Sundry Print Report

Well Name: OMLER A Well Location: T28N / R10W / SEC 35 / County or Parish/State: SAN

Notice of Intent

DHC Completion

Omler A 2 E

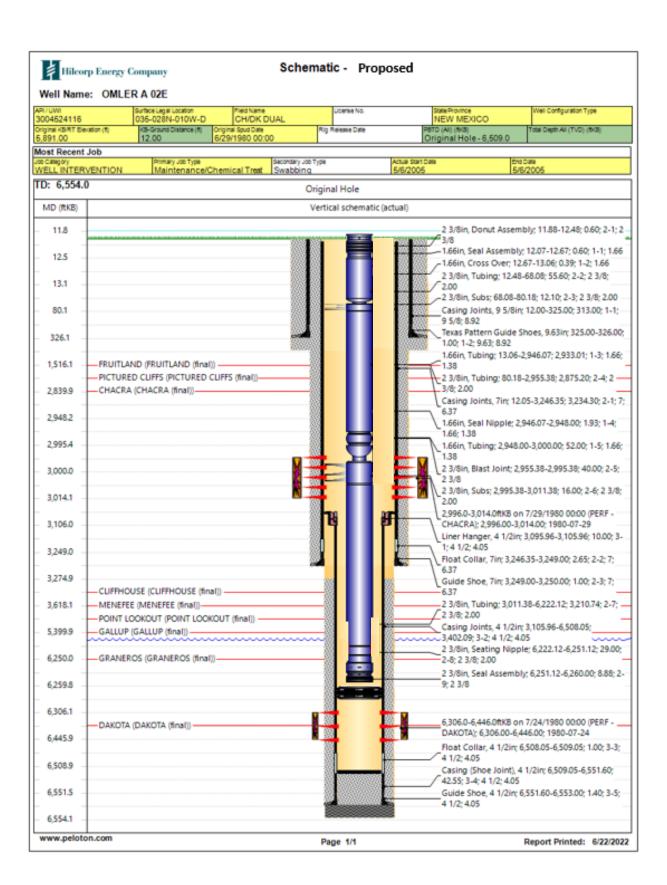
Complete Downhole Commingle CH/DK:

- 1. MIRU Aztec 450 Rig
- 2. Pull CH 1.66" short string. LD
- 3. Unseat 2 3/8" string out of Model "F" packer. POOH scanning out.
- 4. Use RBP and Test Packer to MIT Zone between Existing Model "F" packer and CH Perfs 3014'-6251'
- 5. Use RBP and Test Packer to MIT Zone between CH and Surface Surf'-2996'
- 6. RIH with 2 3/8" production string, land just above existing Model "F" Packer @6251'.

Created By	Condition	Condition Date
mkuehling	Defective packer set below seal assembly at 6251 approved to remain in hole and produce through. Notify NMOCD 24 hours prior to testing. NMOCD witness required on both MITS.	1/27/2023
